INDESIT company

Model type:
TCD851BEU

Commercial code:
F054369

07337-20 Exploded views

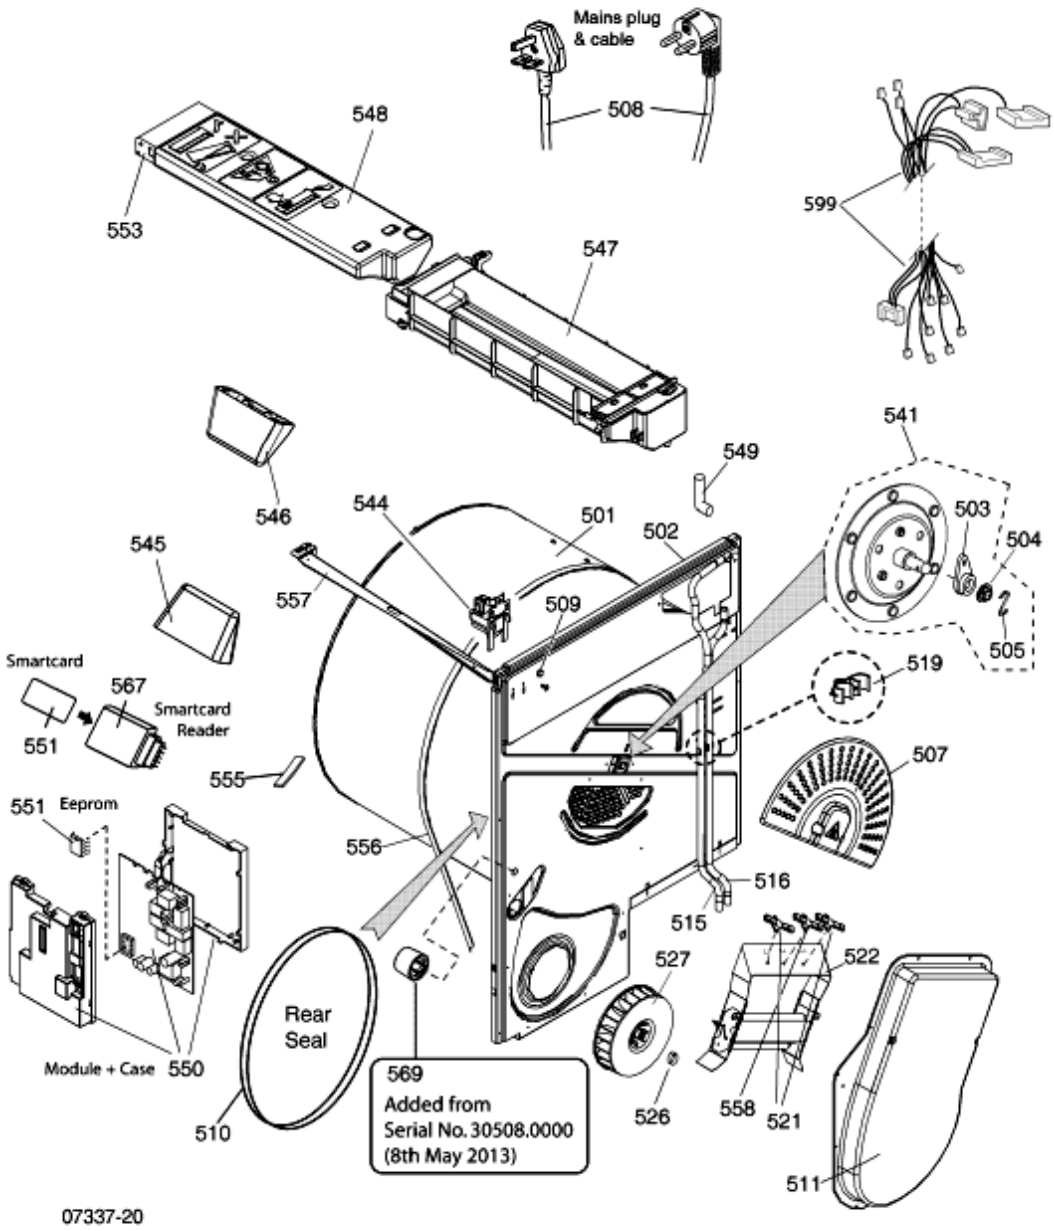
n4408l00: DRUM ASSEMBLY WITH FIXED SHAFT

From Serial Number 80901.0001 a new drum with a fixed (Rivetted) shaft has been introduced in production, this drum is interchangeable and will be supplied as the service spare.

n4410f01: 350 MOTOR AND B Energy BOM Changes

From 16/08/2010, Serial No.0816.0001 the build of some 7.Kg, 7.5Kg & 8Kg level 2 and level 3 B Energy rated condenser dryers changed to a new B Energy build using an A2 control module with 4.5.14 firmware along with a new type 362 motor and 2.3Kw insulated heater assembly. The base unit is based on the Aqualtis B Energy but using the C Energy type condenser unit with the base duct and motor covers removed.

n4410j00: A2 MODULE-DELTA HEATER/BBC CHANGES

A2 MODULE / DELTA HEATER INTRODUCTION
During week commencing 23/11/2009 Serial No.91123.0001 a new A2 power module and heater assembly was introduce in production. This change was gradually introduced starting from the above date with full production due by week commencing 2/01/2010 Serial No.100102.0001. During this period production may vary from the original build to the A2 build depending on availability of A2 components, so to enable easy identification for models produced with the A2 power module and heater assembly, there will be a circular BLUE label (see Attached image) attached to the rear of the machine near the appliance rating plate. The label will be discontinued when full production of A2 module and heater is achieved on 02/01/20010.

07390-05 Exploded views

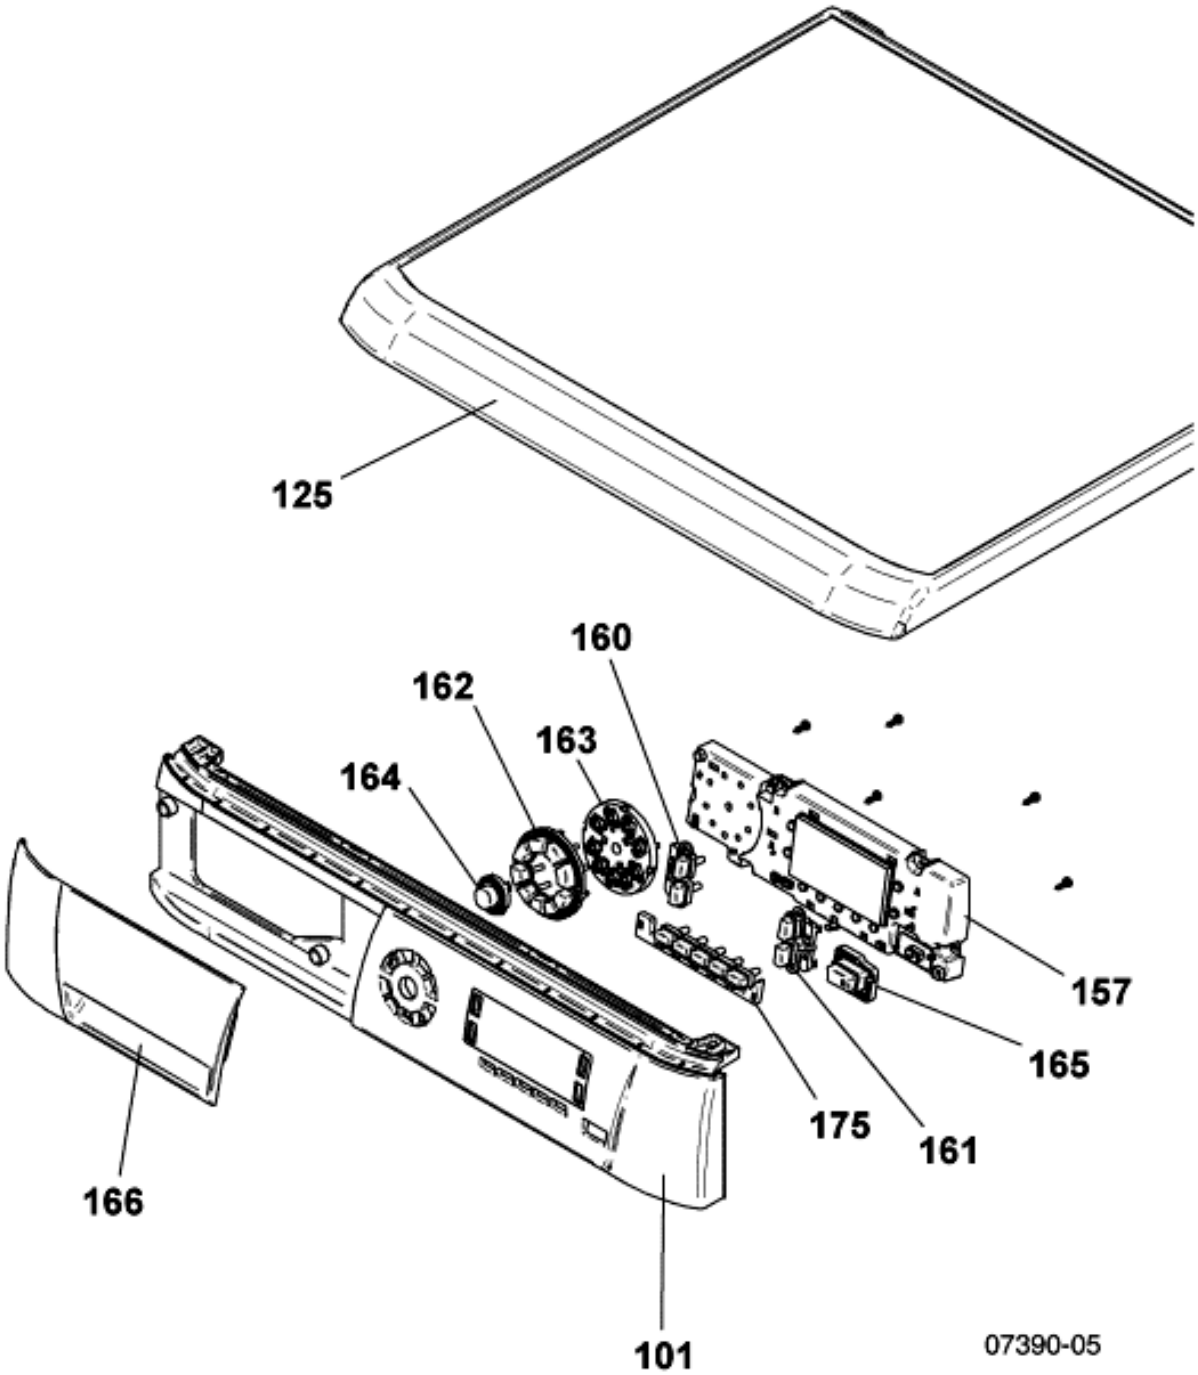
n4409k01: Introduction of Interface Module with Stand–By

From serial number 91102.0001 a new interface module with ‘Stand-By’ was introduced on production and is fitted to all electronic tumble dryers. The "Stand-By" mode is activated after the machine has finished the programme. This module can be used as a direct replacement for the version without Stand-By.

07401-25 Exploded views

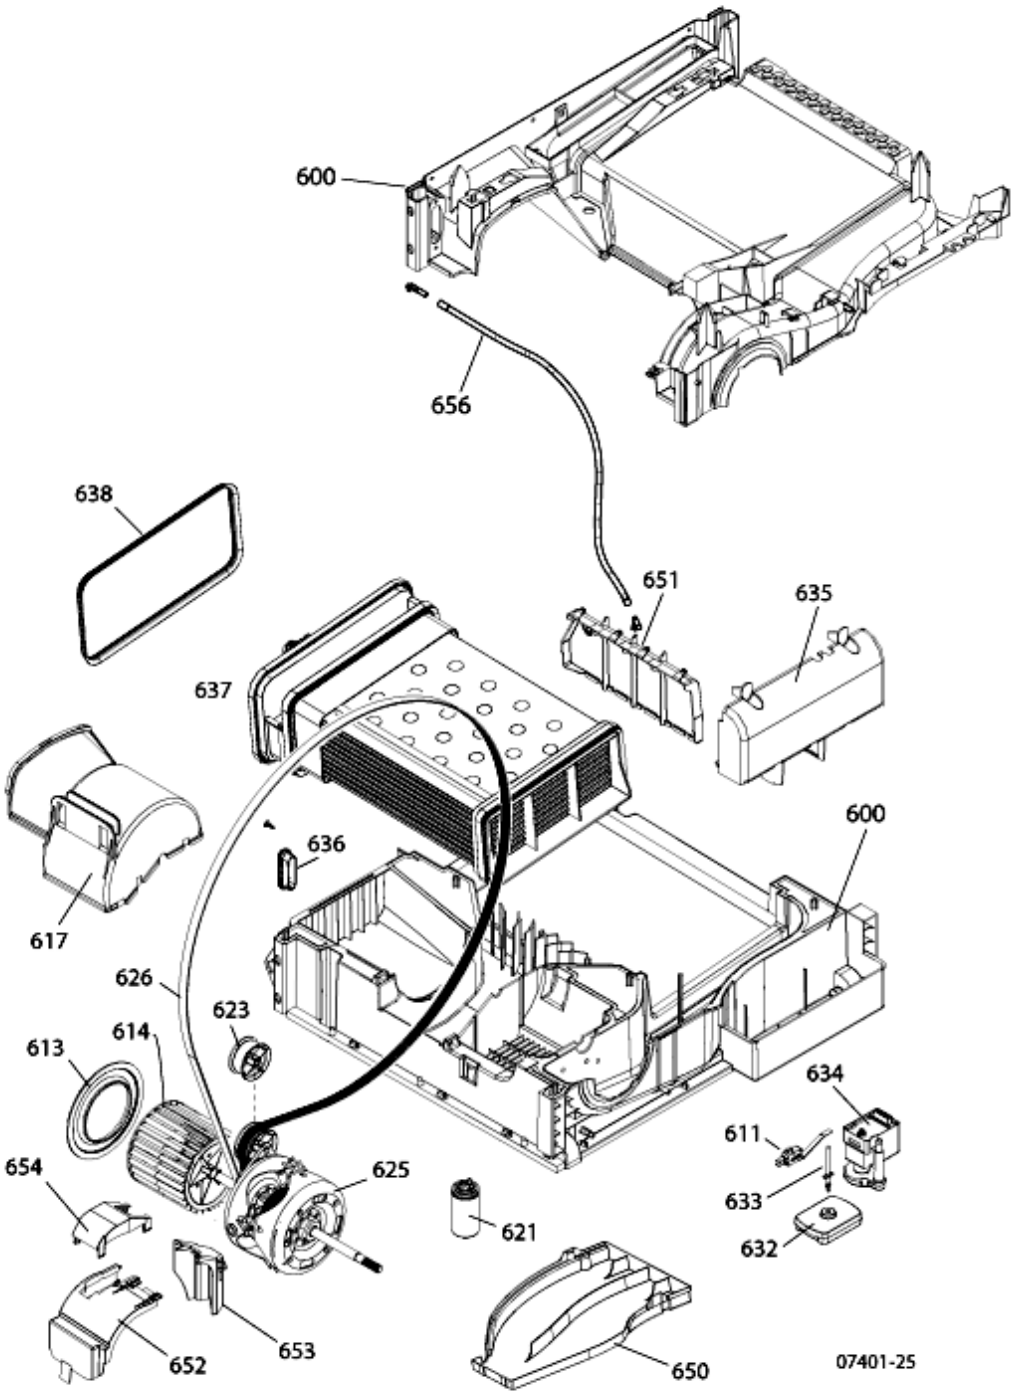
n4413j00: BREAKING BELTS

To overcome the issue of breaking belts the 6 Rib belt has been replaced by the 8 rib belt C00300793

12721-15 Exploded views

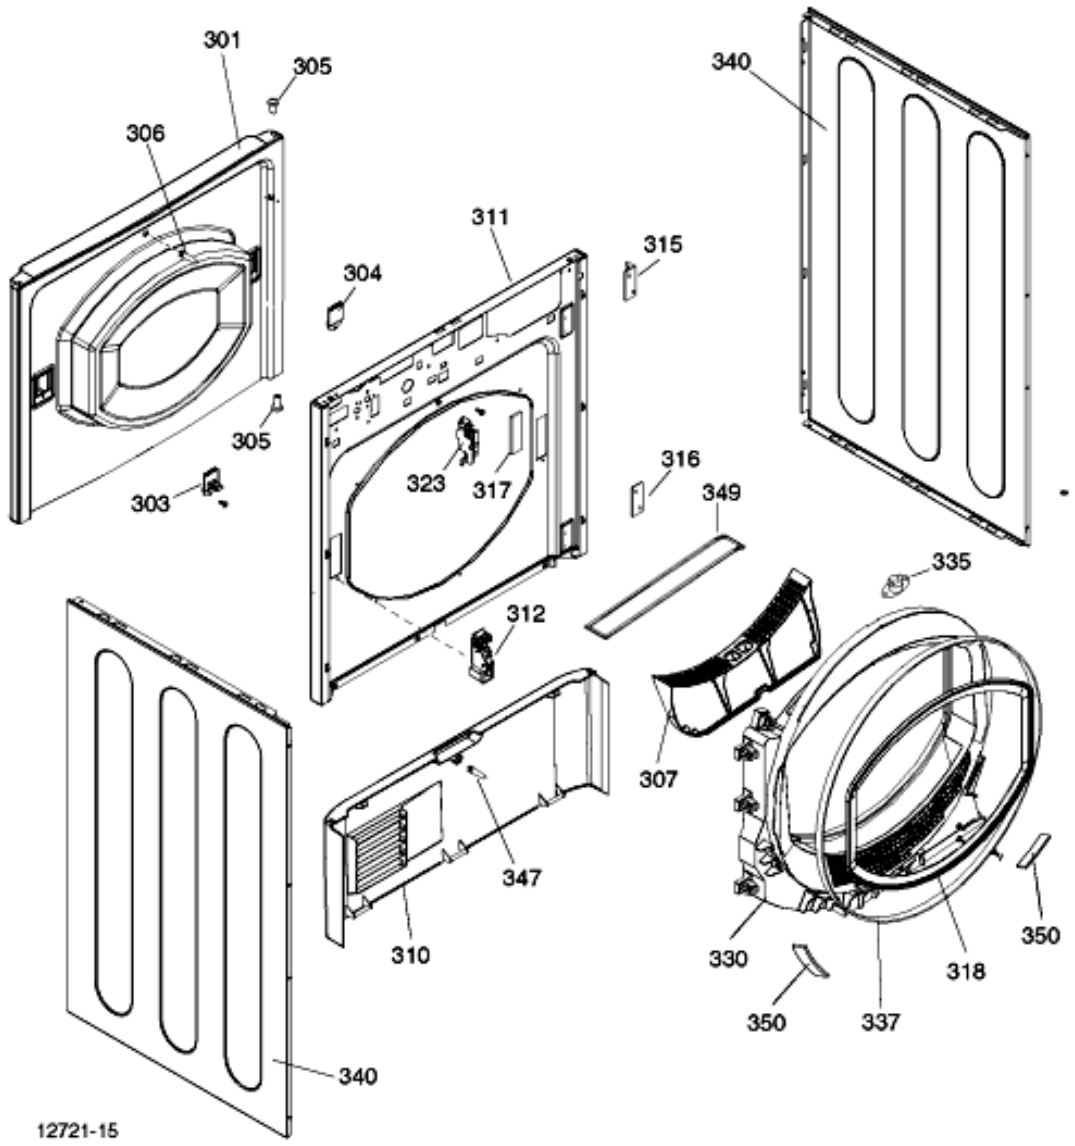
n4411g00: CONDENSER DRYER DOOR SEALS

ON SELECTED TUMBLE DRYERS FROM JUNE 2011 THE DOOR SEAL COLOUR CHANGED FROM GREY TO WHITE.
SELECTED THE CORRECT PART BY DESCRIPTION IN THE PARTS LIST

n4414a03: BEARING PADS REDUCED

FROM JUNE 2013 THE NUMBER OF BEARING PADS FITTED IN PRODUCTION WAS REDUCED FROM 5 to 4.
FROM THIS DATE THE LEFT HAND BEARING PAD (WHEN VIEWED FROM THE FRONT) IS NO LONGER FITTED
